Access Compliance Report

(Curb Ramps)

Intersection ID: 46758	Main Street: CUMBERLAND COVE DR	Cross Street: SUPERIOR ST	Location: SW
ADA ID: F37359E132DC	Ramp Type: PerpDiag	Initial Pass/Fail: Fail	Overall Compliance: No
Severity Score: 8.75			
Codes/Mitigation Info/Possible Solution		Field Measurements/Component Compliance

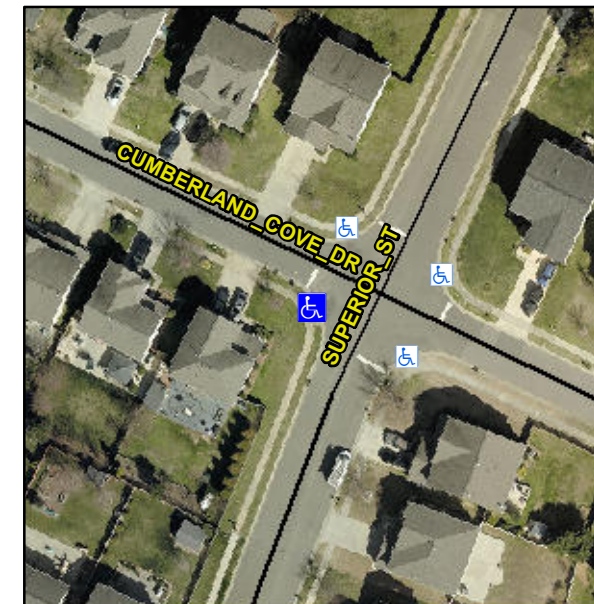
Remove & Replace Curb Ramp With Two New Directional Ramps or Equivalent.

R304.5.1
